Reliability Analysis Update

Transmission Expansion Advisory Committee
May 8, 2026

- 2026 RTEP - Window 1
 - Schedule Update
- 2025 RTEP - Window 1
 - P5 Updates
- Scope / Cost Changes
- NJ SAA Project Cancelations

Canceled Projects: MAOD Proposal 551

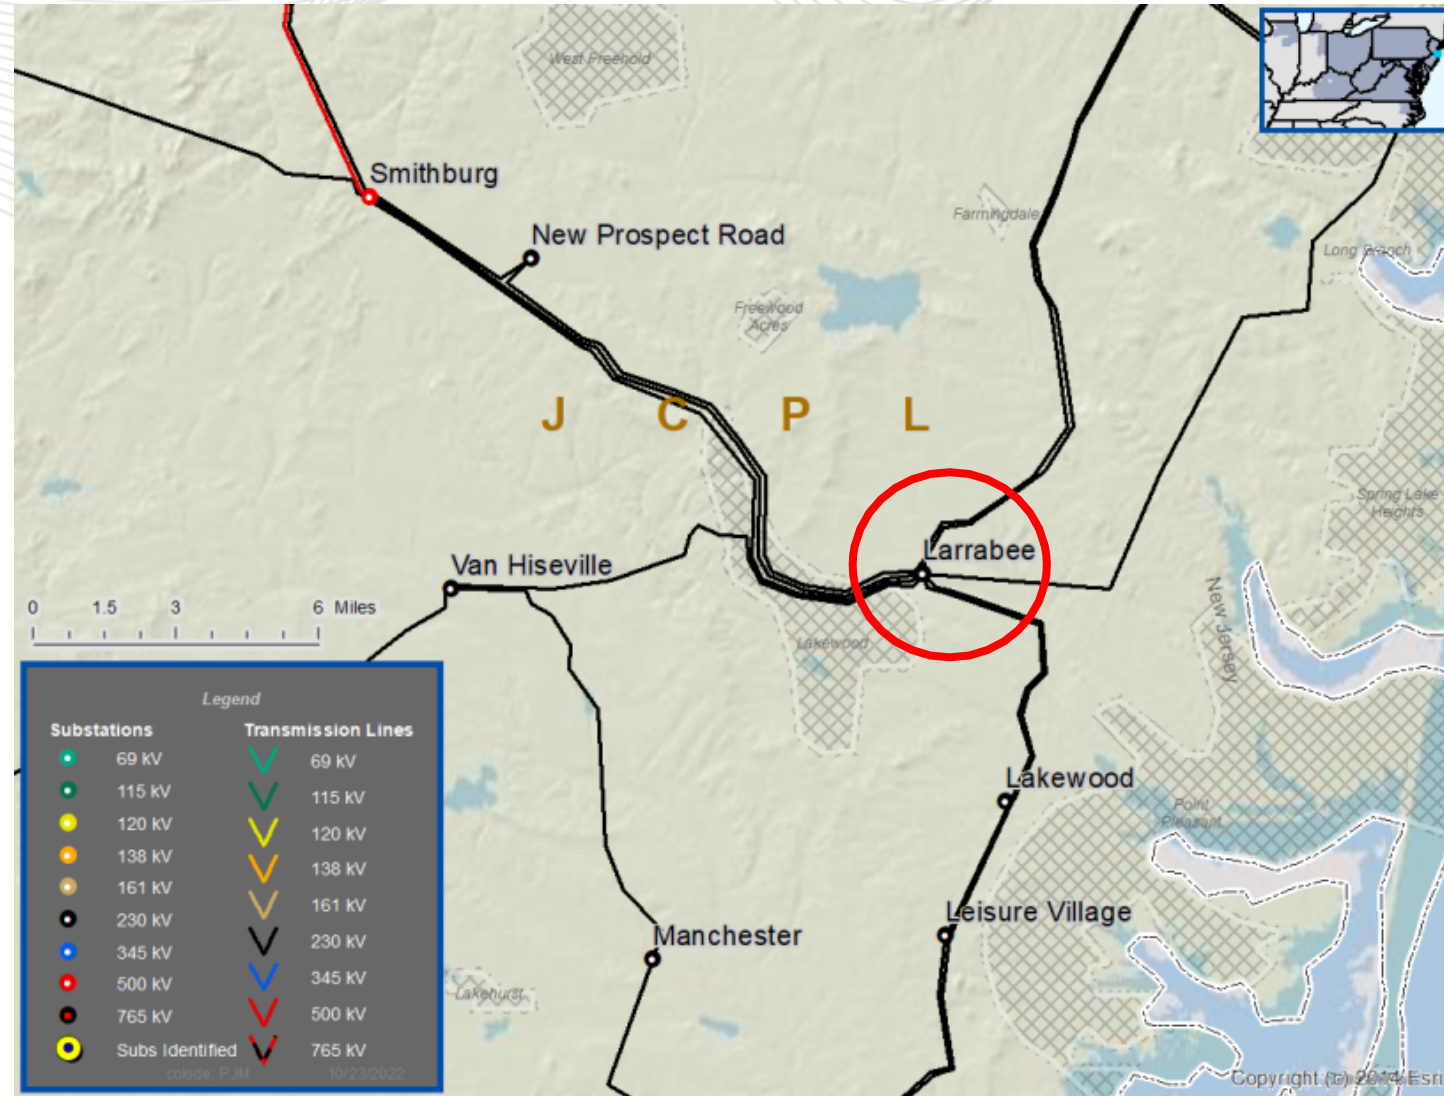
- Construct the Larrabee Collector station AC switchyard, composed of a 230 kV 3 x breaker and a half substation with a nominal current rating of 4000 A and four single phase 500/230 kV 480 MVA autotransformers to step up the voltage for connection to the Smithburg substation.
- Procure land adjacent to the AC switchyard and prepare the site for construction of future AC to DC converters for future interconnection of DC circuits from offshore wind generation. Land should be suitable to accommodate installation of four individual converters to accommodate circuits with equivalent rating of 1400 MVA at 400 kV. Additional scope includes three sets of AC collector lines from the LCS to the offshore wind converter station area. (b3737.22)

Canceled Project: ACE Proposal 127

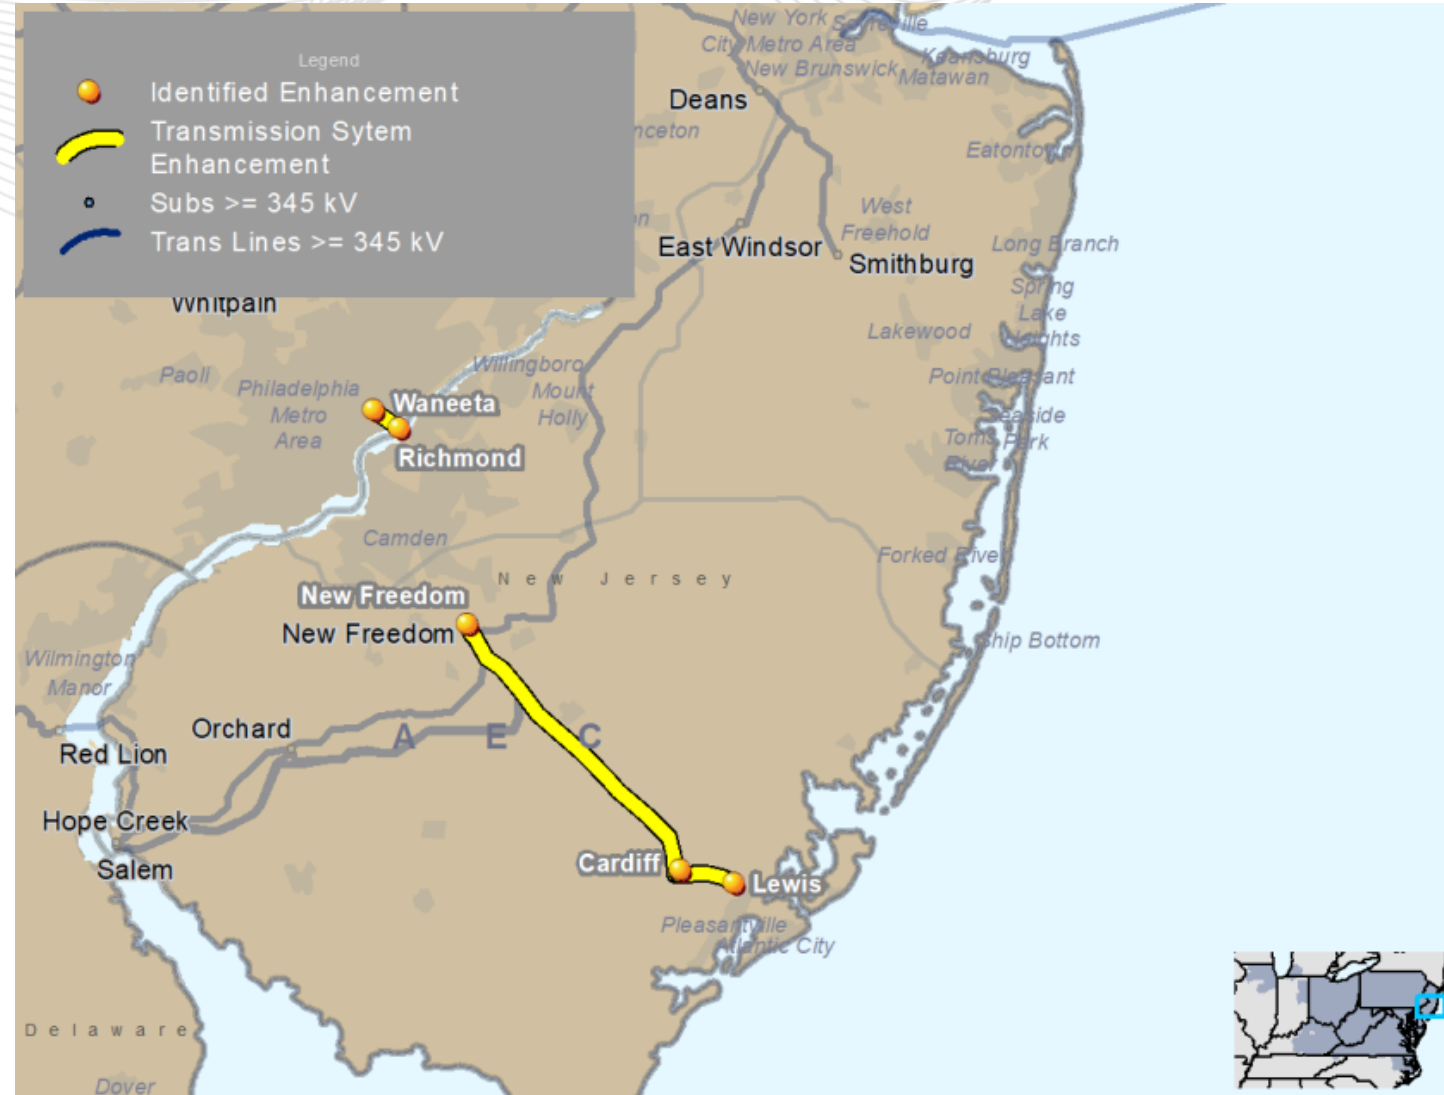
- Upgrade Cardiff-New Freedom 230 kV by modifying existing relay setting to increase relay limit (b3737.26)

Canceled Projects: JCPL Proposal 17

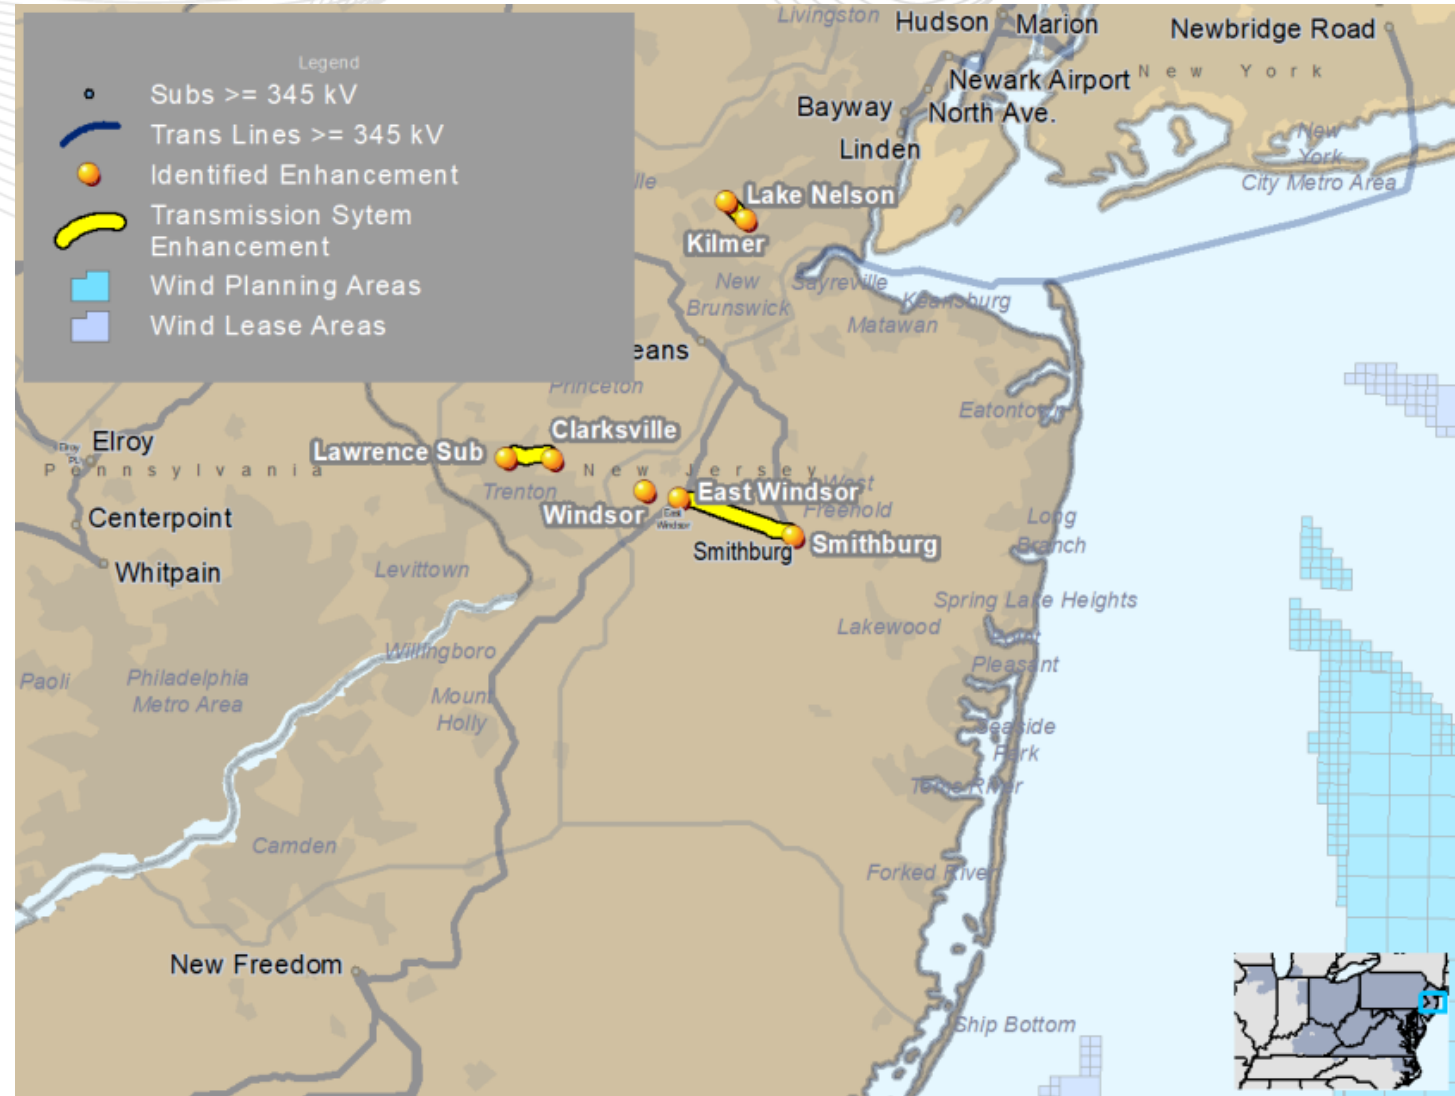
- Rebuild approximately 0.8 miles of the D1018 (Clarksville-Lawrence 230 kV) line between Lawrence substation (PSEG) and structure No. 63 (b3737.27)
- Reconductor Kilmer I-Lake Nelson I 230 kV (b3737.28)
- Additional reconductoring required for Lake Nelson I-Middlesex 230 kV (b3737.31)
- Middlesex substation 230 kV – Replace the 2000A circuit switcher at Middlesex switch point for the Lake Nelson I1023 230 kV exit. (b3737.55)

- Convert the six-wired East Windsor-Smithburg E2005 230 kV line (9.0 mi.) to two circuits. One a 500 kV line and the other a 230 kV line (b3737.29)
- Windsor to Clarksville subproject: Upgrade terminal equipment at Windsor 230 kV. (b3737.59)

- Add third Smithburg 500/230 kV transformer (b3737.30)

Canceled Projects:

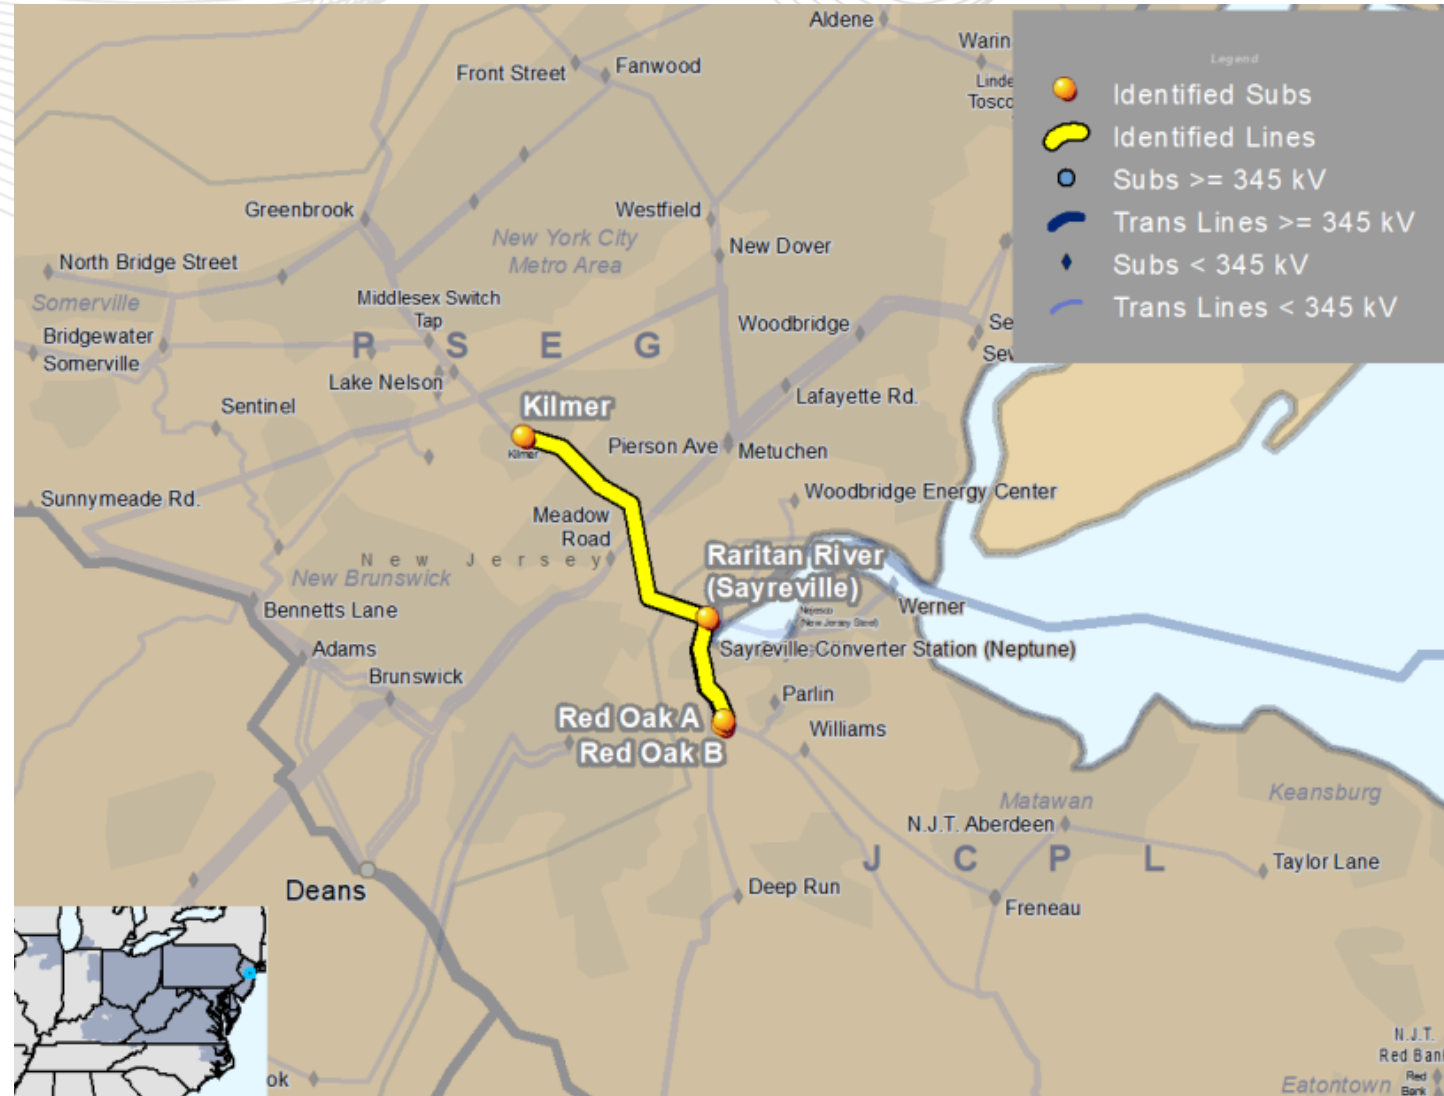
- Reconductor Red Oak A-Raritan River 230 kV (b3737.33)
- Reconductor Red Oak B-Raritan River 230 kV (b3737.34)
- Reconductor small section of Raritan River-Kilmer I 230 kV (b3737.35)
- Replace substation conductor at Kilmer and reconductor Raritan River-Kilmer W 230 kV (b3737.36)

Canceled Project: LS Power Proposal 229

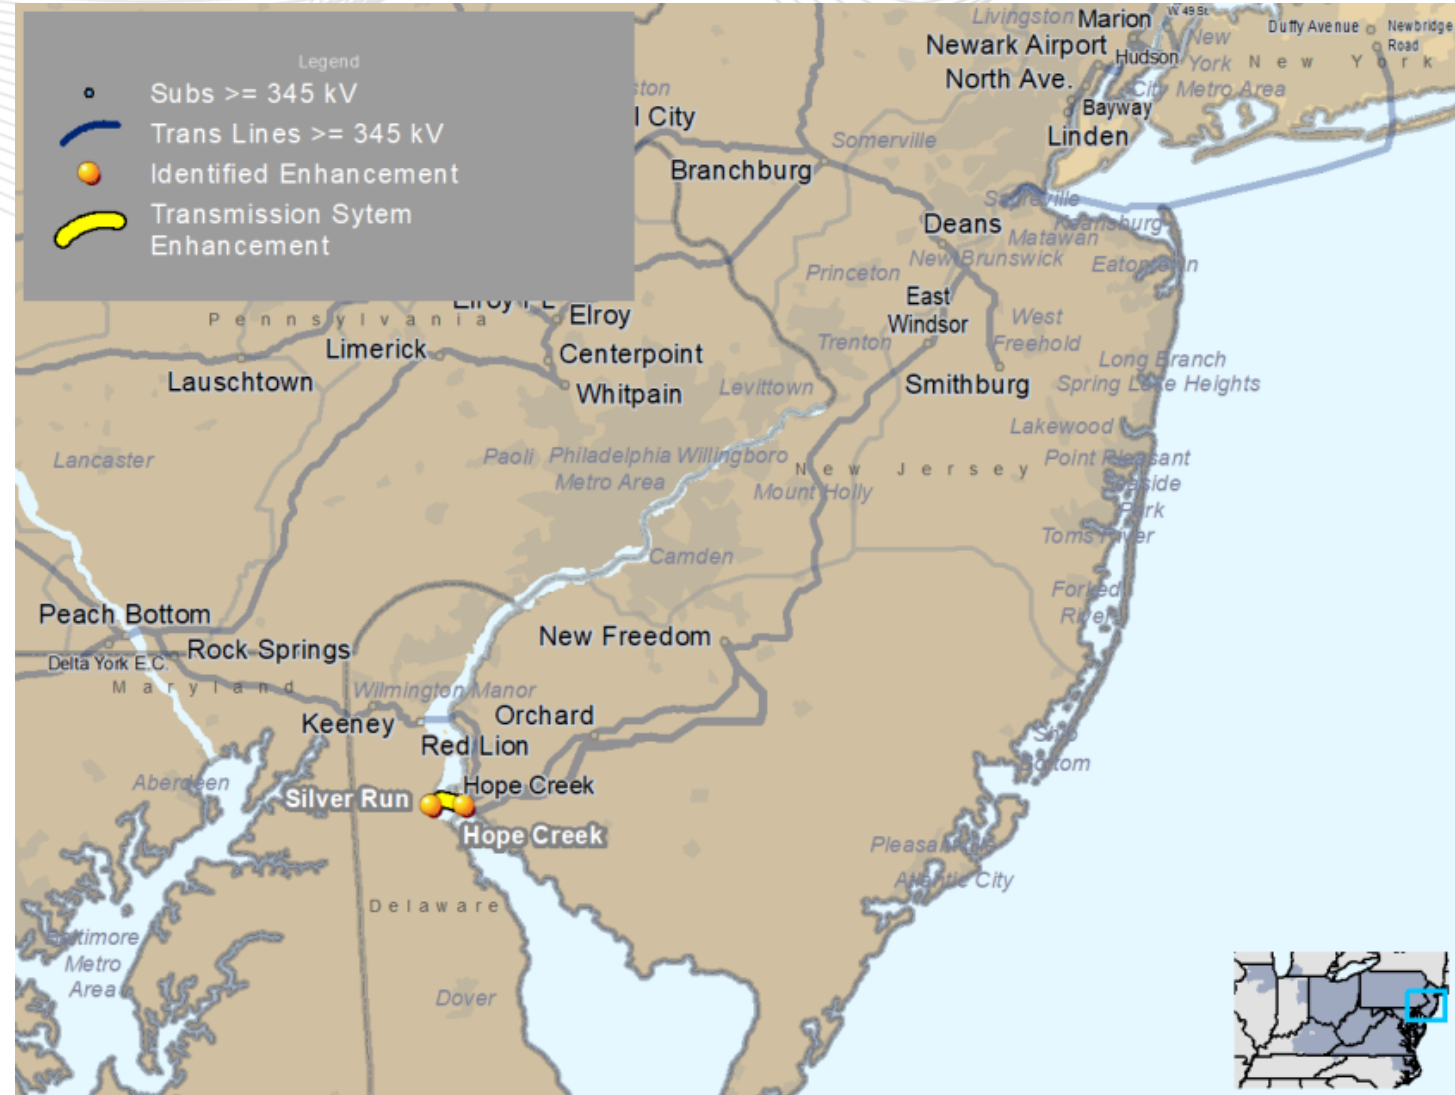
- Add a third set of submarine cables, rerate the overhead segment, and upgrade terminal equipment to achieve a higher rating for the Silver Run-Hope Creek 230 kV line (b3737.37)

Canceled Project: PSEG Proposal 180

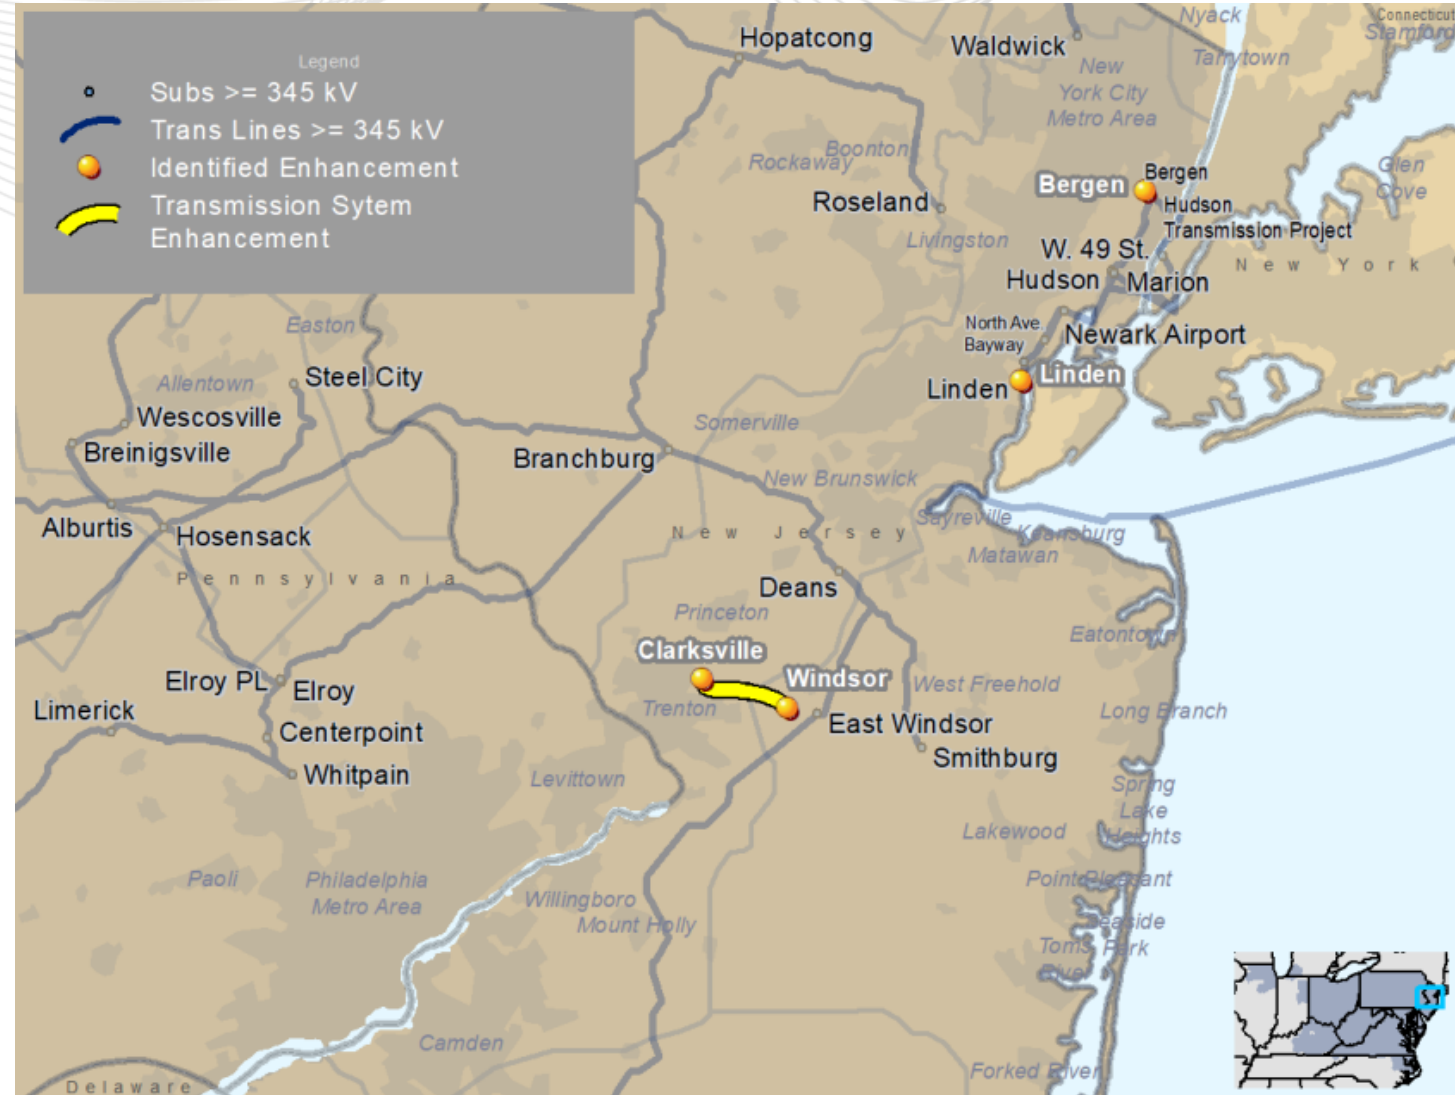
- Windsor to Clarksville subproject: Reconductor one span of the C1017 (Clarksville-Windsor) 230kV line from structure #126 to Windsor Substation with double bundled 1590 ACSR conductor, approximately (0.1) mile (b3737.40)
